COUNTY OF SAN MATEO
RECONSTRUCTION OF SEVENTH AVENUE FROM MIDDLEFIELD ROAD
TO EDISON WAY IN THE NORTH FAIR OAKS AREA
COUNTY ROAD NUMBER 561-A

COUNTY PROJECT NO. RW703
PROJECT FILE NO. E4957000

ADDENDUM NO. 2

7 (REV)
SHEET 7 OF 15

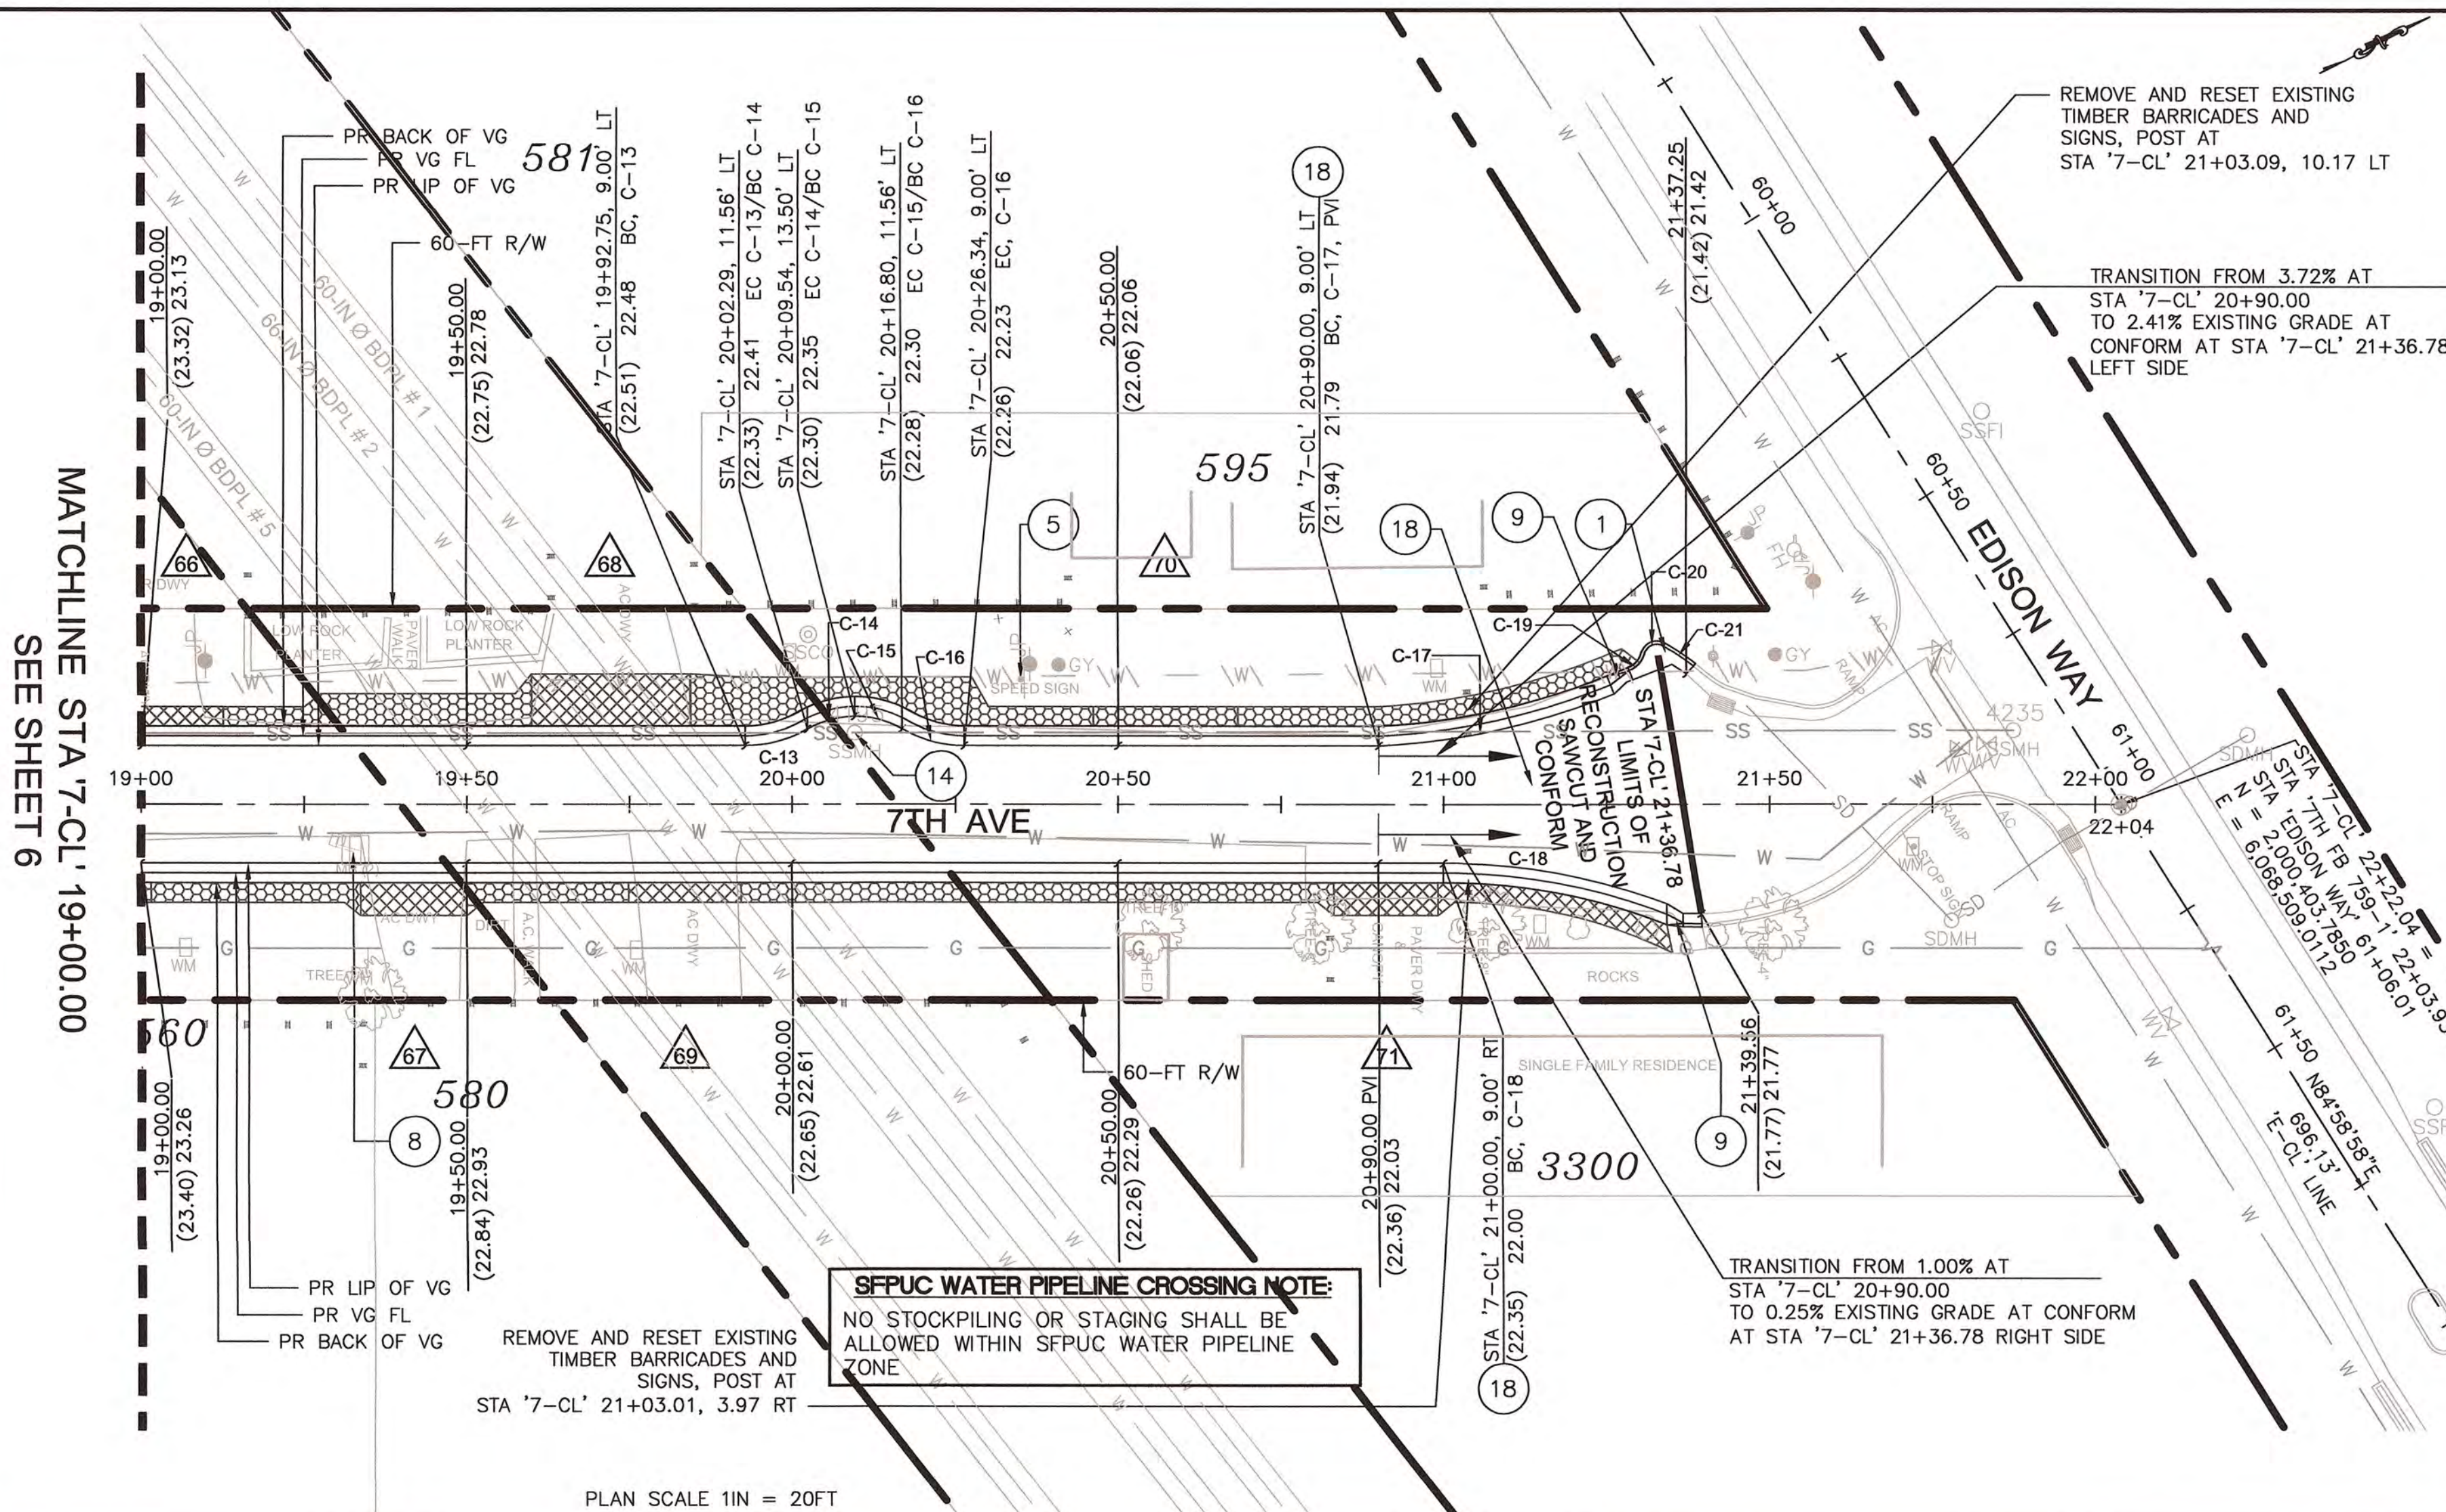
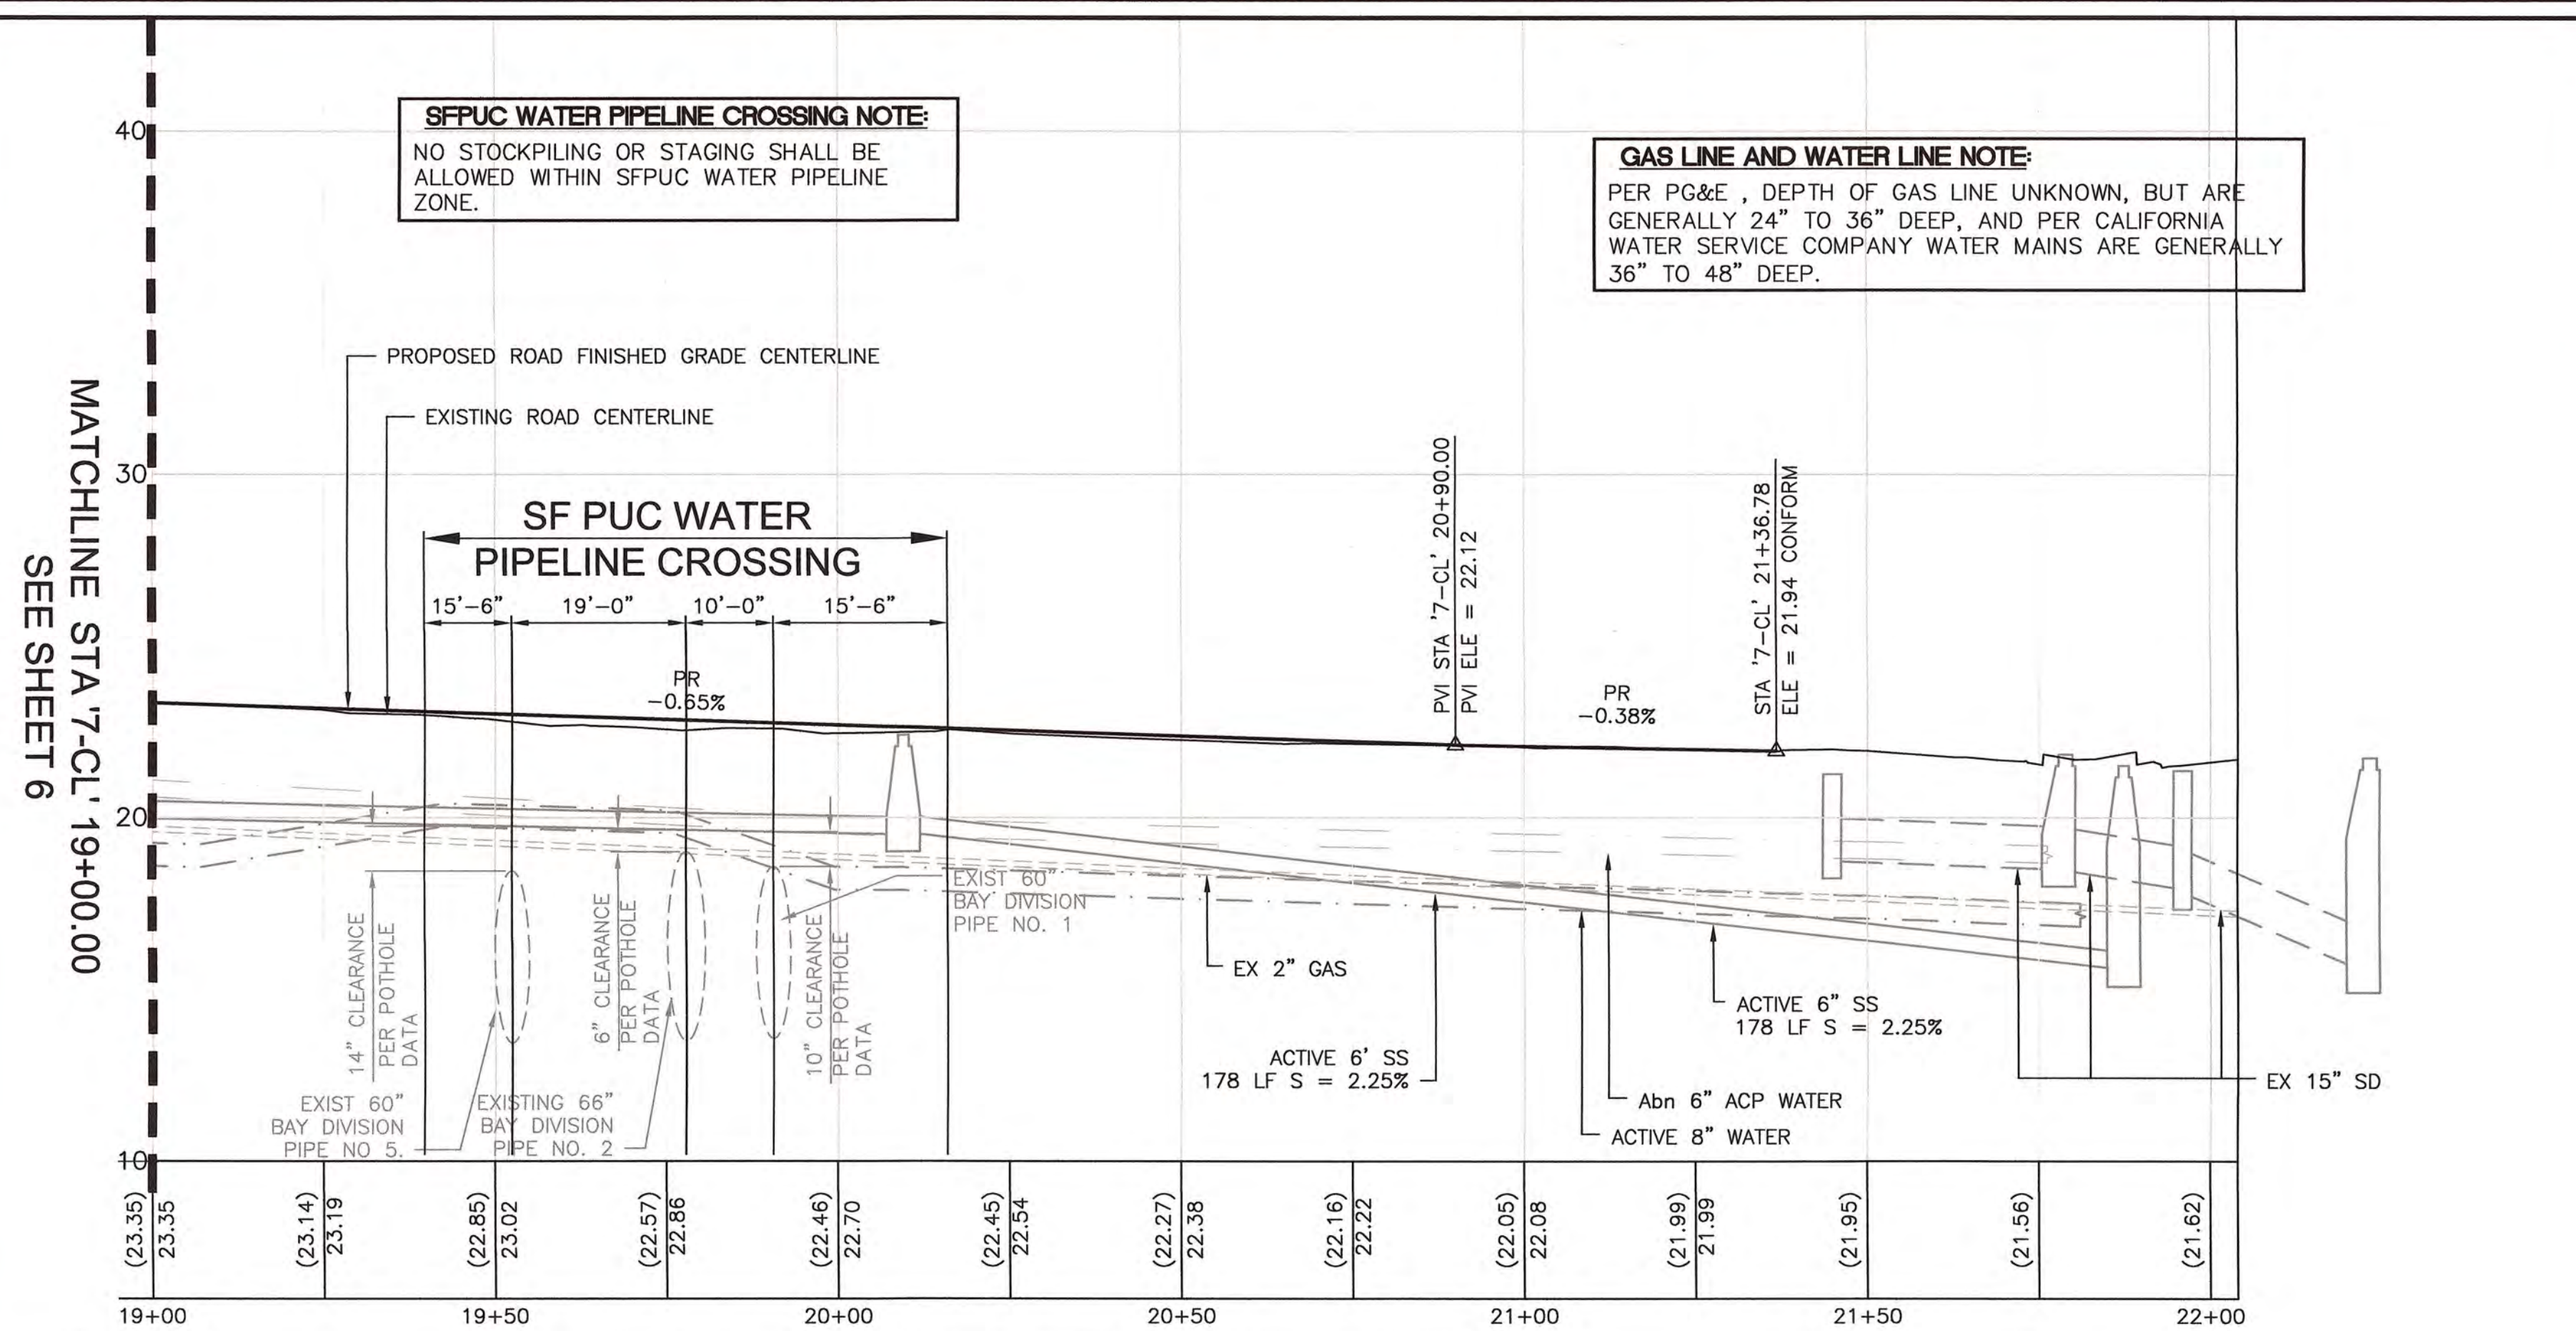
UPDATES:
1.) HATCH PATTERNS DARKNESS ADJUSTED TO MATCH THE PLAN AND LEGEND
2.) "ASPHALT CONCRETE" LABEL CHANGED TO "MISCELLANEOUS ASPHALT CONCRETE" LABEL
